CLEARANCE

The purpose of this information sheet is to provide specific guidance targeted at areas within the fabrication process that will lead to improvements in the finished product. It is our aim to educate and provide awareness that will save our customers money from correcting potential design flaws.

No Clearance

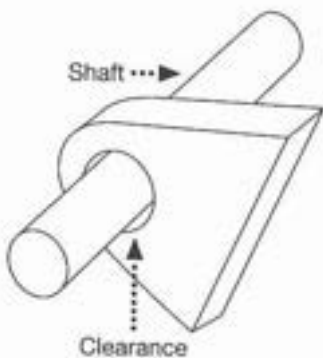
One of the most common problems encountered is insufficient clearance between bracket and drop bolt. As can be seen in the photo the zinc has sealed the gap between pin and plate preventing the pin from moving freely. If the gate is then to be powder coated there will be no chance of the drop bolt being free enough to function.

No? - The solution is a simple one. Leave around a 2mm to 3mm gap between bracket and bolt. Measure this evenly around the drop bolt. This allows for the zinc coating to be applied and for the drop bolt to move freely. What to look for is a rattle fit.

**2mm to 3mm
Clearance**
